**Meeting Date:** Tuesday 3 September 2013  
**Location:** Committee Room 2, Level 5, Civic Centre, 1 Devlin Street, Ryde  
**Time:** 5.00pm

<b>Item</b>		<b>Page</b>
1	CONFIRMATION OF MINUTES - Meeting held on 6 August 2013.....	1
2	32 KEPPEL ROAD, RYDE - LOT 225 DP 12999. Development Application for the construction of a double garage within the front setback of the dwelling and an awning to the side of the dwelling. LDA2013/0131. <i>INTERVIEW 5.00PM</i> .....	4
3	92 CONSTITUTION ROAD WEST, MEADOWBANK. Lot 2 DP 12059. Local Development Application to demolish laundry and construct new outbuilding/garage at the rear of the property. LDA2013/0046. <i>INTERVIEW</i> .....	48

- LDA2013/0131 was lodged on 19 April 2013. The development application seeks to construct a new detached double garage and associated enclosed walkway within the front setback and replace the approved hard stand area with landscaping.

**Sightlines to footpath and road obstructed as a result of the proposed development from No. 30 Keppel Rd, Ryde**

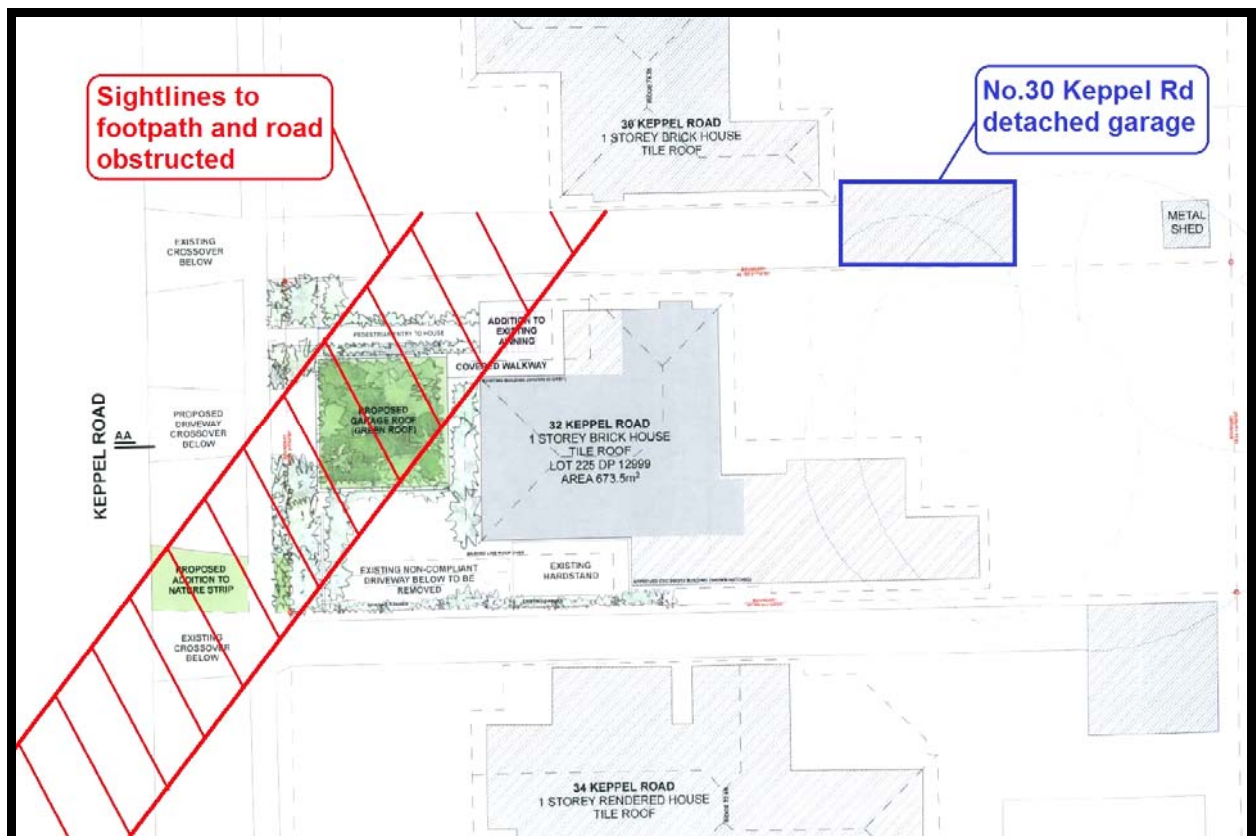
Assessment Officer's Comment: Pedestrian and vehicular safety were identified as an issue in the assessment of the proposed development. As the proposed garage is to be setback from the front boundary only 1.35m, it is considered that insufficient sightlines will be provided to the footpath and roadway to allow for the safe entry and exit to the allotment.

**Sightlines to footpath and road obstructed as a result of the proposed development from No. 34 Keppel Rd, Ryde**

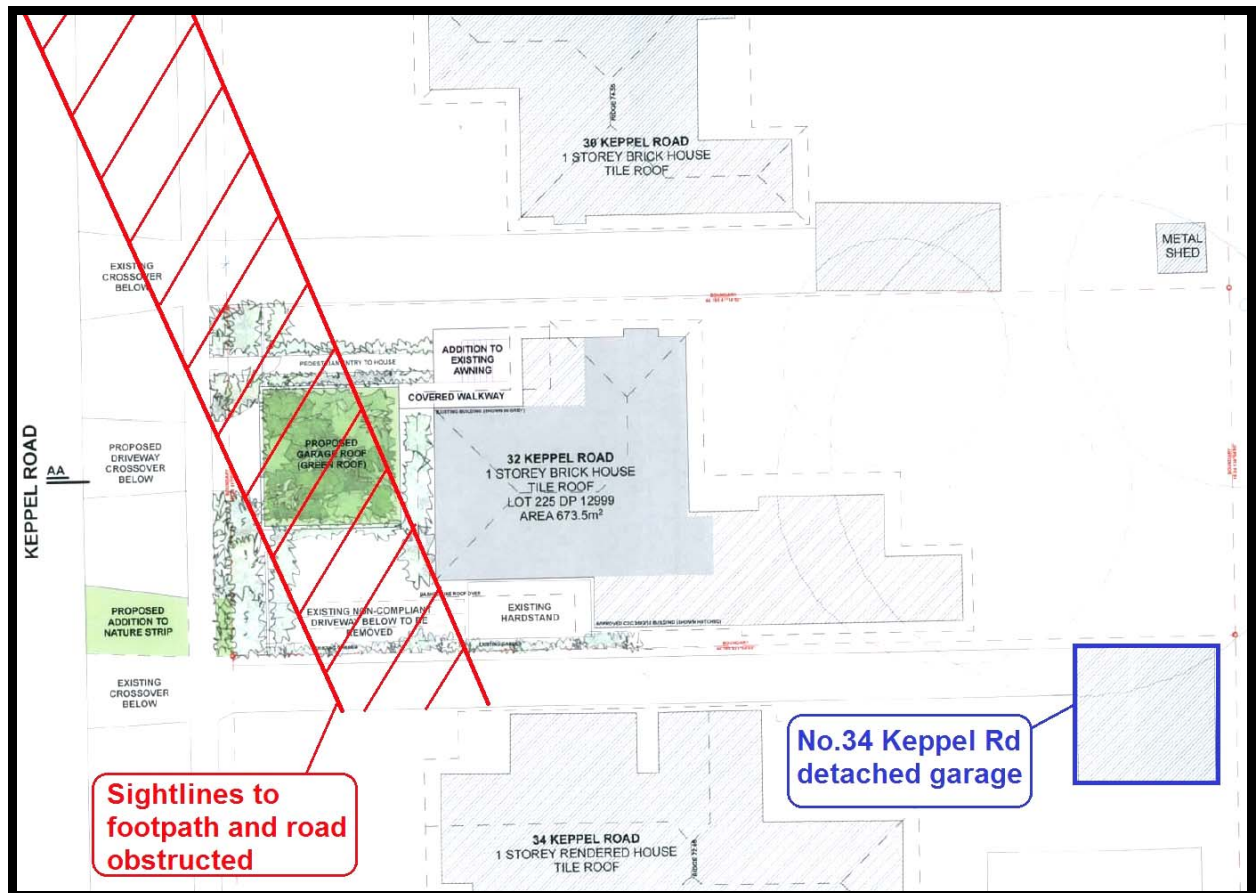
Additionally, due to the forward location of the proposed garage and its minimal setback to the front boundary, sightlines are considered to be obstructed from the neighbouring allotments when exiting the driveways, thus potentially creating further impacts upon the safety of pedestrians and vehicles. As demonstrated in the sightline drawings (see below), the location of the driveways to both 30 and 34 Keppel Road are adjacent to the boundary of 32 Keppel Road therefore, resulting in the existing sightlines across the allotment significantly reduced as a result of the proposed development.

Given the above, it is considered that objection based upon the proposal impacting pedestrian and vehicular safety is supported.

**Proposed setbacks to the boundary and footpath**

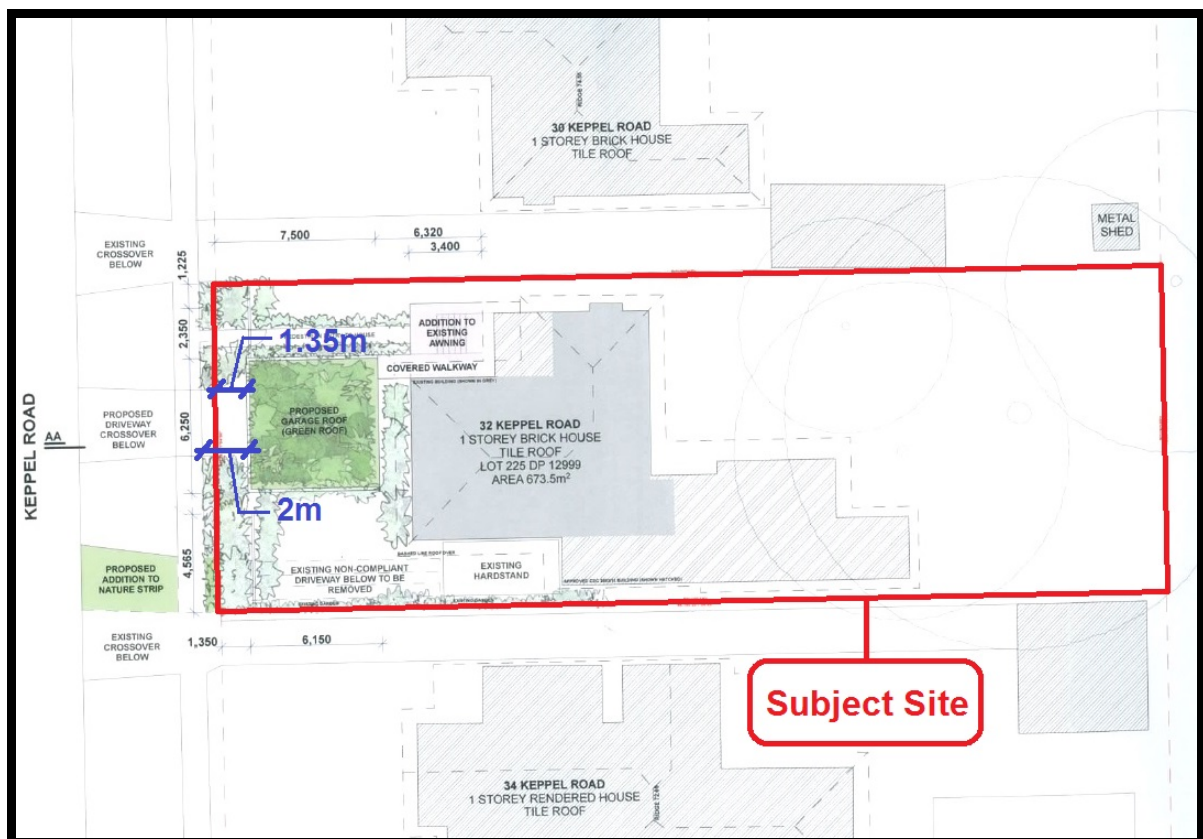
setback to the front boundary, sightlines are considered to be compromised through an obstruct view from the neighbouring allotments when exiting the driveways which may further impact upon the safety of pedestrians and vehicles. As demonstrated in the sightline analysis drawing (above), the location of the driveways to both 30 and 34 Keppel Road are adjacent to the boundary of 32 Keppel Road therefore seeing the existing sightlines across the allotment significantly reduced.

In this regard it is considered that the level of pedestrian and vehicular safety resulting from the proposed detached double garage is unacceptable and cannot be supported.

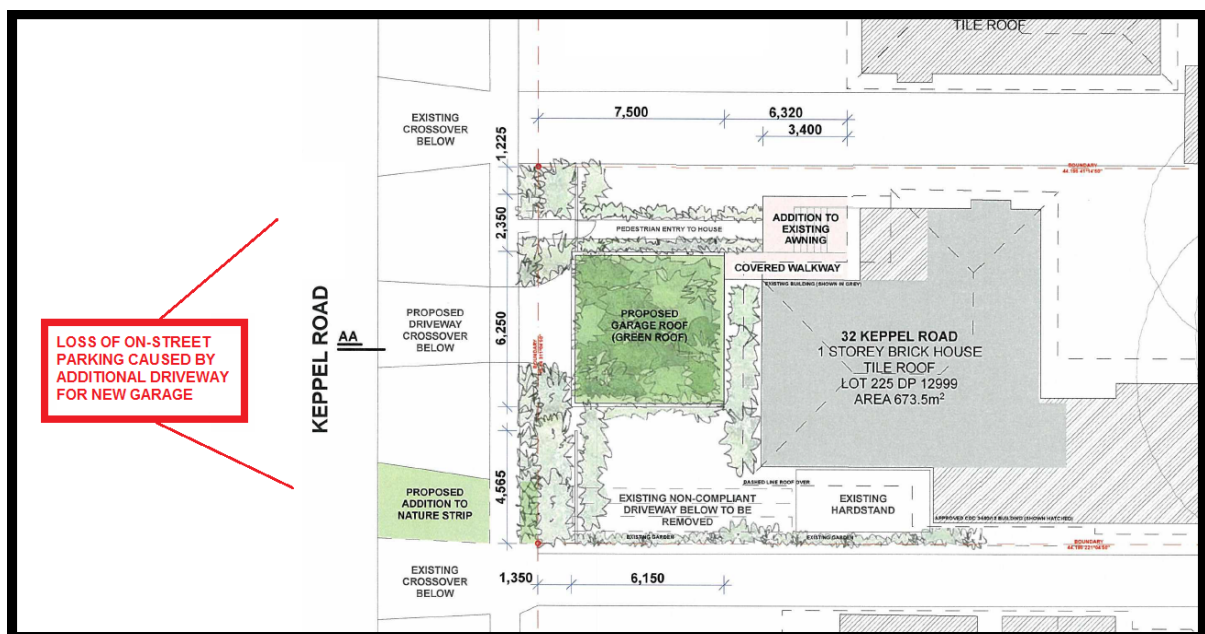
- *The proposed new crossing is located right adjacent to an existing kerb inlet pit which cannot be supported as it needs to be located a minimum of 600mm away from the lintel/pit as it would undermine the structural integrity of this existing council pit;*
- *The proposed garage design does not provide sufficient sight distance to ensure pedestrian and vehicle safety as they exit from the garage which is contrary to AS 2890.1:2004. This cannot be supported as the location of the garage cannot provide this adequate sight distance/lines and therefore it is recommended that a redesign of the garage be undertaken to ensure there this complies with the AS2890.1:2004.*

As shown in the diagram below, the addition of another driveway (having regard to the location of existing driveways) will reduce the space available for on-street parking at the front of the site. This is therefore a further issue of concern regarding the proposal in addition to the other concerns (including streetscape impacts and pedestrian and vehicle safety) that have been discussed throughout this report.

If Council is mindful to approve the application, then it will be necessary to re-locate the kerb inlet pit which is located at the front of the site at the applicant's cost. Whilst this is physically possible and could be imposed as a condition of consent, it should be noted that the costs associated with such work would be around \$5,000 to \$10,000.

**Figure 3:** Standing on the rear verandah of 90 Constitution Road West. The side view looking west across 92, 94 and 96 Constitution Road West to Meadowbank Park.

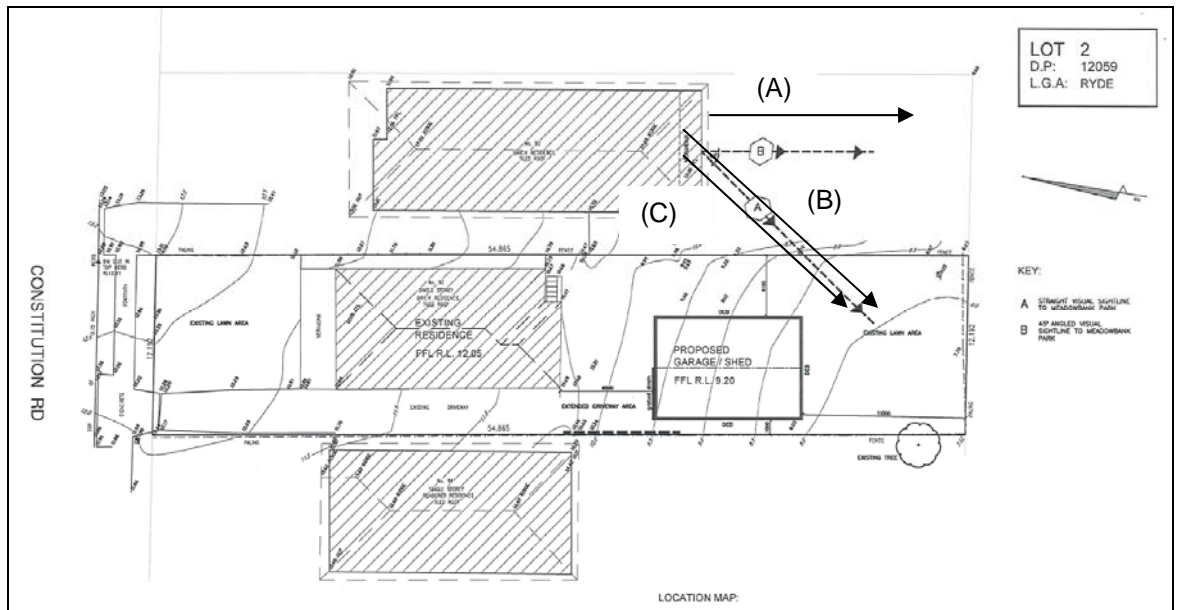
Furthermore, the outlook towards the park from the objector's property (No 92) is a side view across the subject site, and it is well known that side views are more difficult to protect. This is shown in the following plan and photo. The increased rear setback of the outbuilding/garage in the applicant's amended plans also helps to open up the view from the objector's property.

**Figure 6:** The rear portion of the building is a maximum of 750mm higher than Council's control (see below).

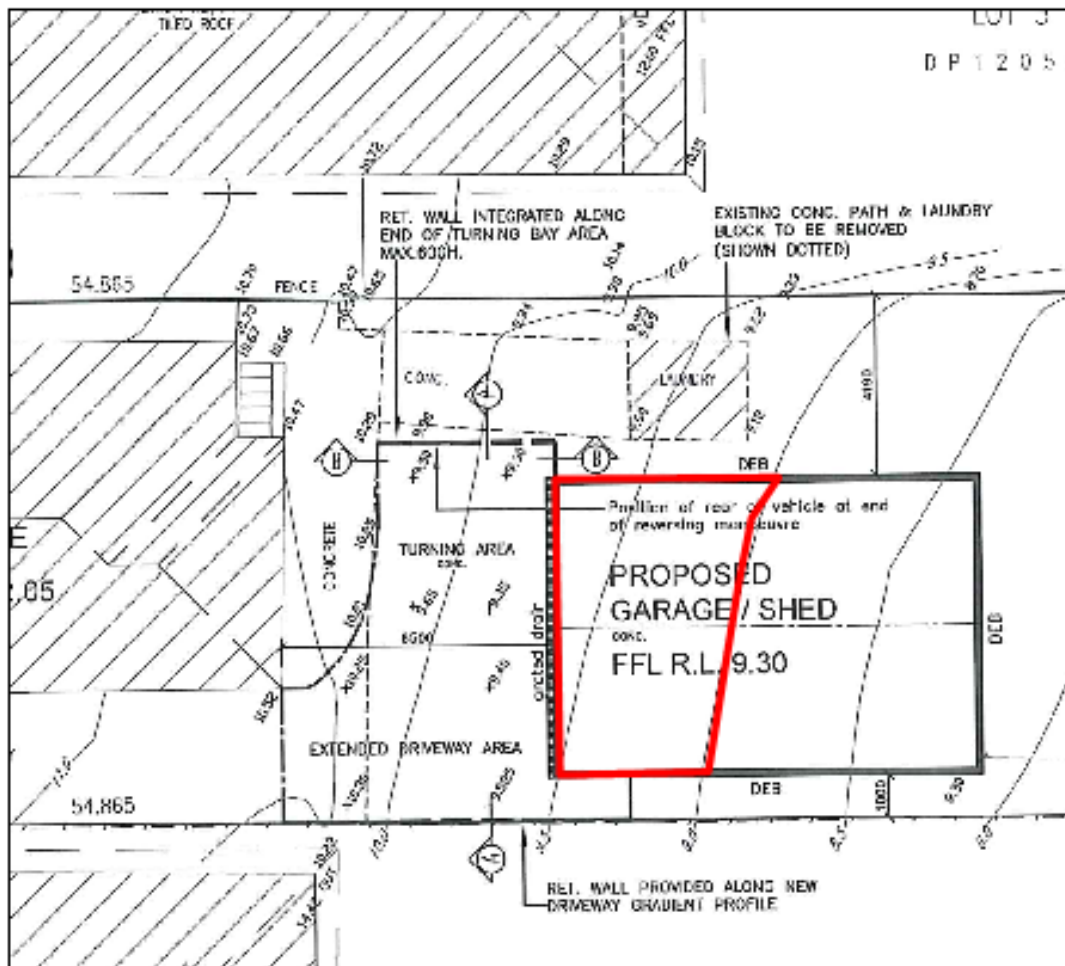
The overall maximum height of the building is 4.3m at the front and up to 5.25m at the rear of the building. The front part of the garage has been cut in up to 450mm to reduce the height at the rear of the garage. The front portion of the building complies with Council's control (see below).

**Figure 7:** Maximum 750mm portion of non-compliance with Council's DCP 2010.

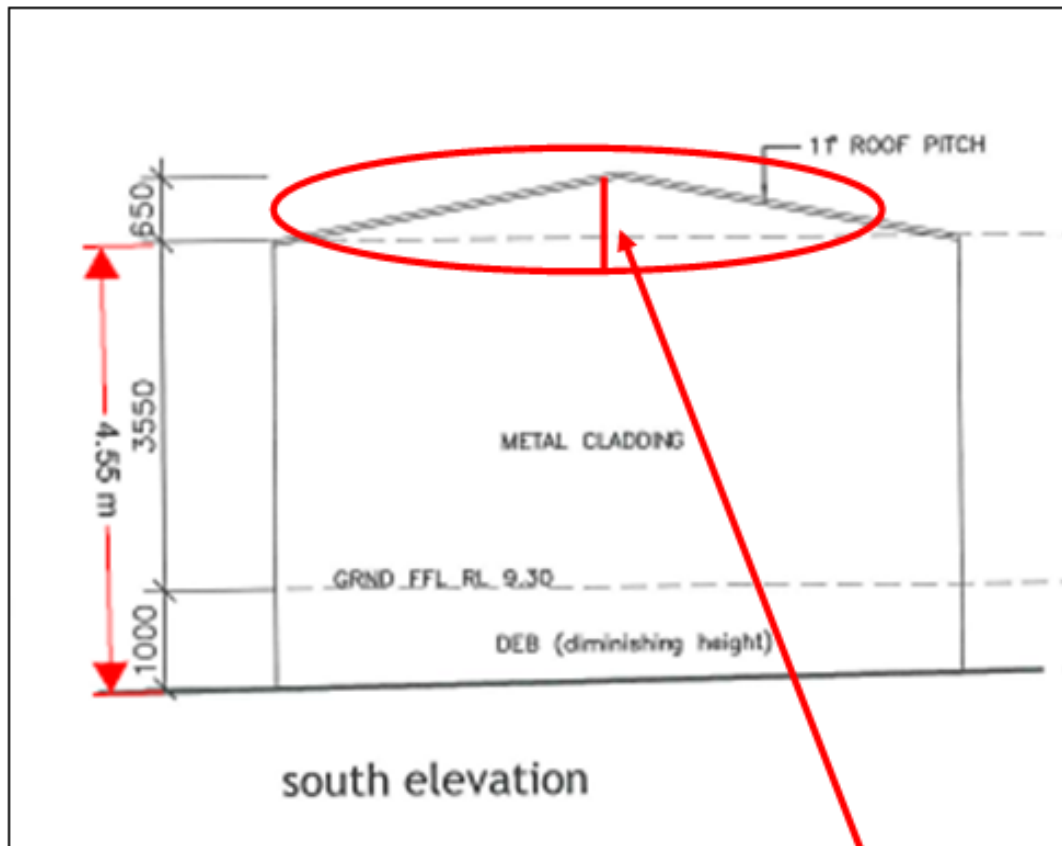
The maximum ceiling height proposed is 3.55m at the front of the garage and 4.6m at the rear which does not comply with Council's control.

In this instance the height is considered satisfactory.

**Figure 14:** Area of fill within the footprint that is 150mm over Council's control.

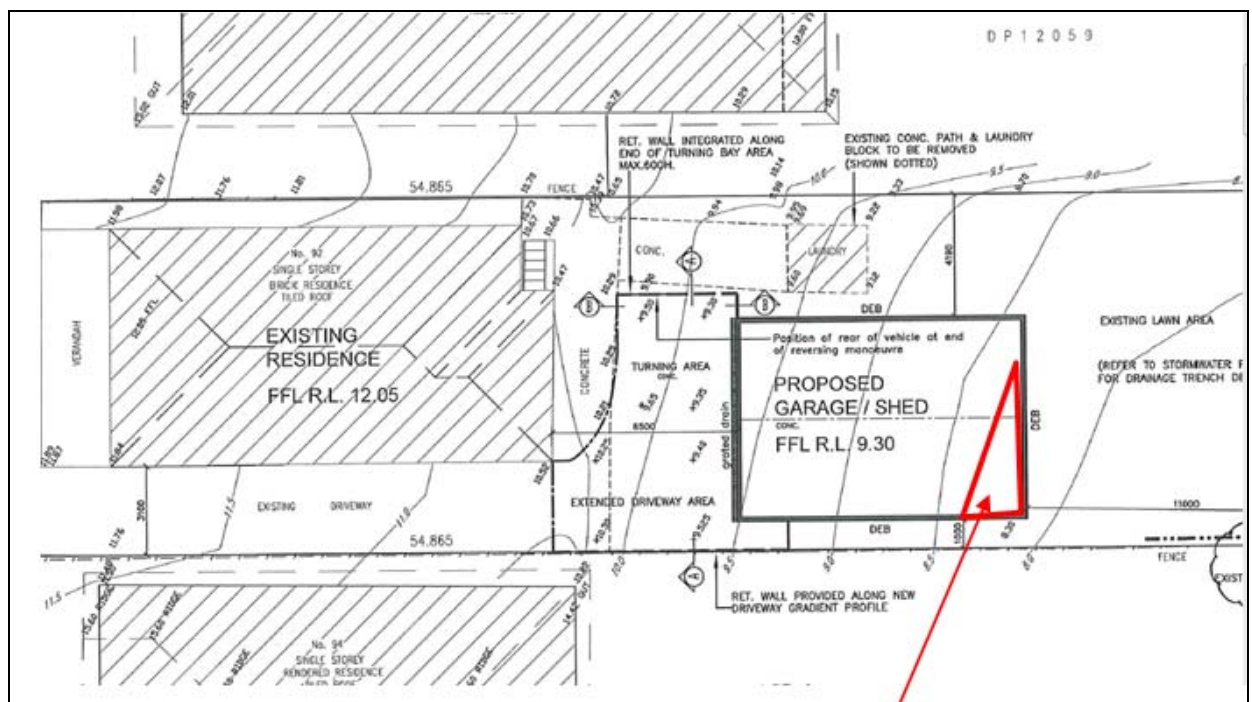
Due to the topography of the site, the rear wall of the building has fill from 850mm to a maximum of 1050mm. This is 150mm over Council's control. The area of fill is a considerable distance from any adjacent dwellings. The encroachment is for a small portion at the rear of the building and is considered satisfactory.

**Figure 15:** The front portion of the building complies with Council's control

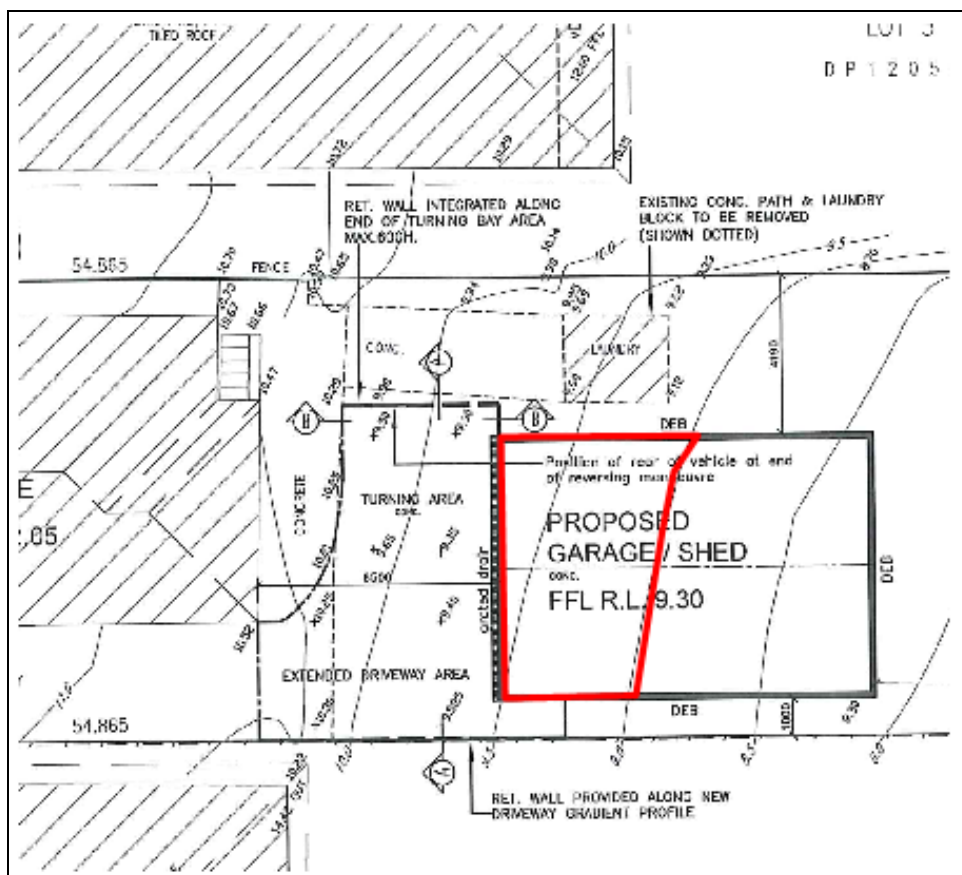
The overall maximum height of the building is 4.3m at the front and up to 5.25m at the rear of the building. The front part of the garage has been cut in up to 450mm to reduce the height at the rear of the garage. The front portion of the building complies with Council's control (see below).

**Figure 16:** Maximum 750mm portion of non-compliance with Council's DCP 2010.

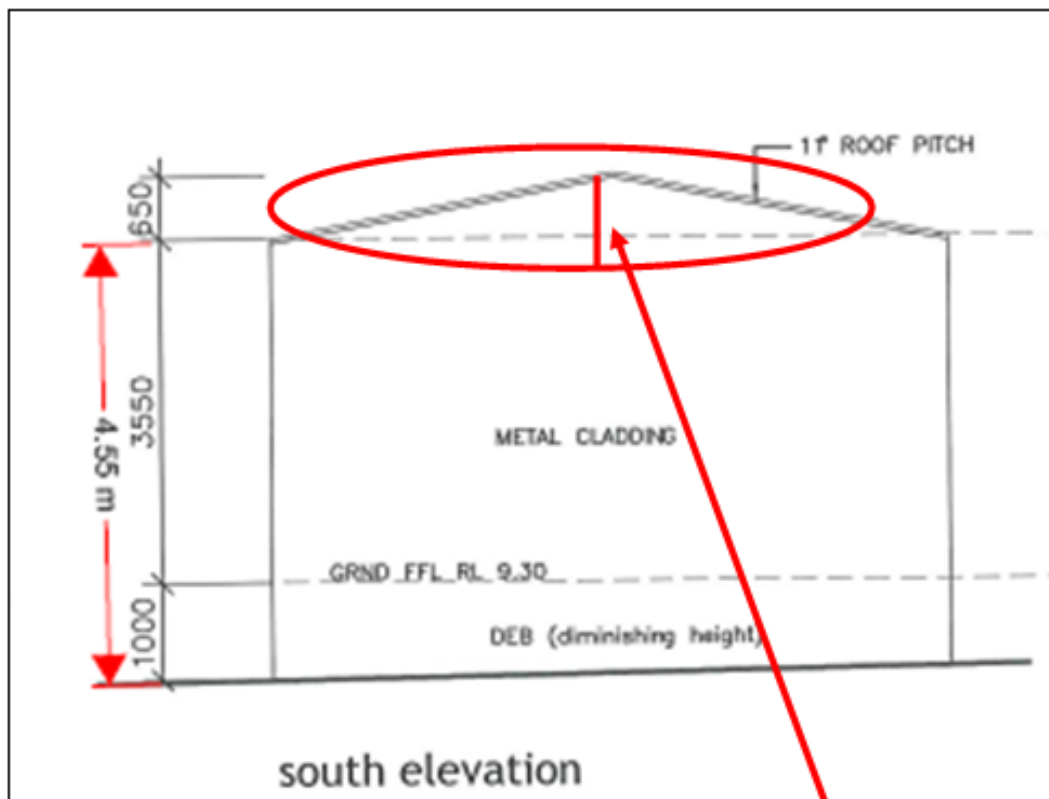
The maximum ceiling height proposed is 3.55m at the front of the garage and 4.6m at the rear which does not comply with Council's control.

In this instance the height is considered satisfactory.
